NEW MEXICO
ENVIRONMENT DEPARTMENT

Hazardous Waste Bureau

December 16, 2009

**RE: NOTICE OF DISAPPROVAL
INVESTIGATION REPORT GROUP 2
WESTERN REFINING SOUTHWEST INC., BLOOMFIELD REFINERY
EPA ID# NMD089416416
HWB-GRCB-09-004**

Figure 3

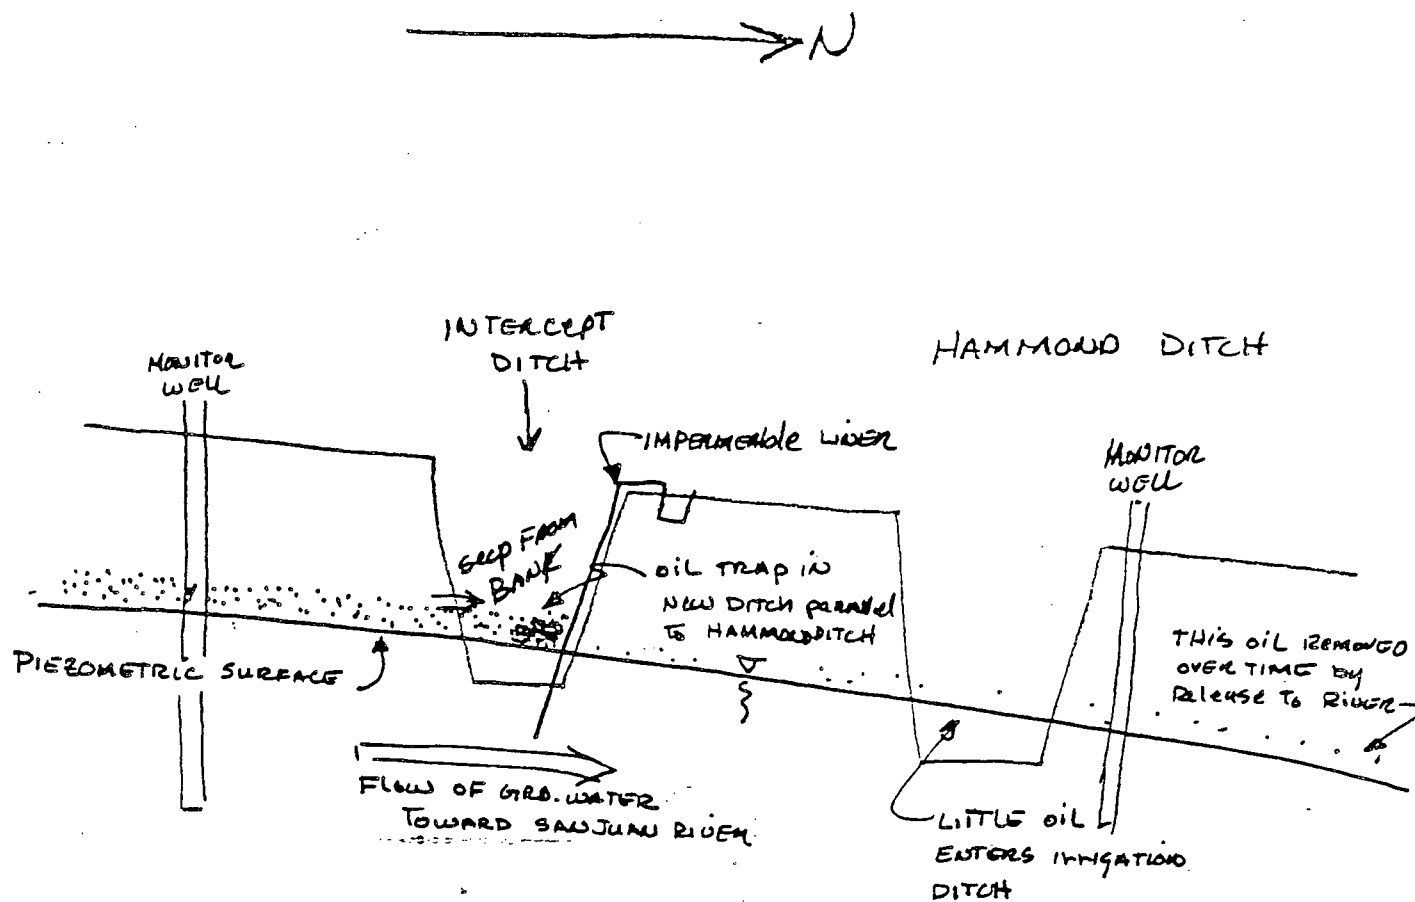
8. The area of heavily polluted soils containing oil (inspised oil) will continually recharge the Hammond Ditch. This area should be treated to intercept the oils for disposal. The oil is lighter than water hence will be present on the piezometric surface. This does aid in capture of the oil if it is moving toward the ditch. Figure 1 indicates that during the summer irrigation season the oil on the surface should flow to the south because the piezometric surface should dip in that direction due to heavy recharge to the aquifer by the ditch. Then as the irrigation season ends the ditch no longer recharges the aquifer and the piezometric surface reverses allowing the oil to flow northward into the ditch and likely beyond to seeps in the cliff.

The oil can be captured using the method shown in Figure 3. The existing monitor wells may be useful in design of such a clean up operation. The problem with removal wells is the requirement for constant pumping and a place to dispose of the wastestream. Using the ditch method it is possible to hold the oil until the plant manager is ready to remove the oil scum.

The oil on top of the water would be trapped behind the impermeable liner for later collection and disposal. Depth of oil and water must be determined before design and construction of intercept ditch.

Figure 4a

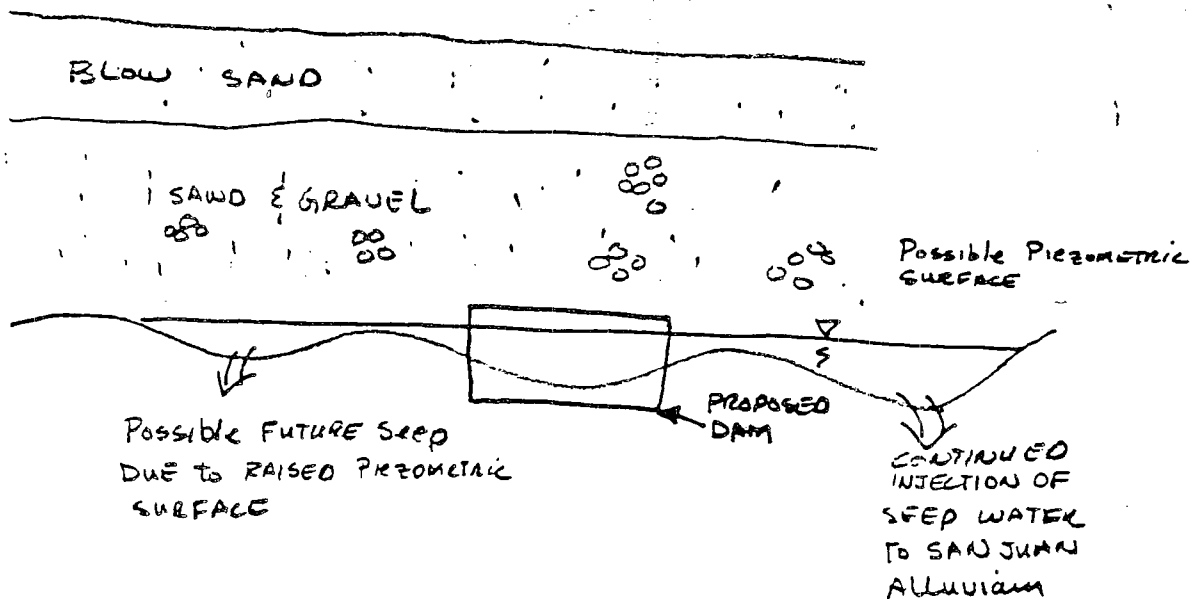
15. The proposal to recycle the wastewater from the seeps does not eliminate the chance for further pollution of the San Juan River alluvium. According to the Plateau report the Nacimientto formation is undulating as seen in the exposed section of the Cliff. Therefore, once a dam is placed at a seep the water level will rise and may seek an outlet requiring less hydraulic head. Figure 4 shows the potential for continued injection into the river aquifer which essentially will continue the existing situation. According to the Plateau plan these new seeps would also have a dam built. It does not seem to be a reasonable scheme for protection of the groundwater. In addition, according to the literature the Nacimientto formation does have layers of sand that can transmit water at high flow rates. The information provided does not exclude the possibility that wastewater is recharging such layers in the formation.
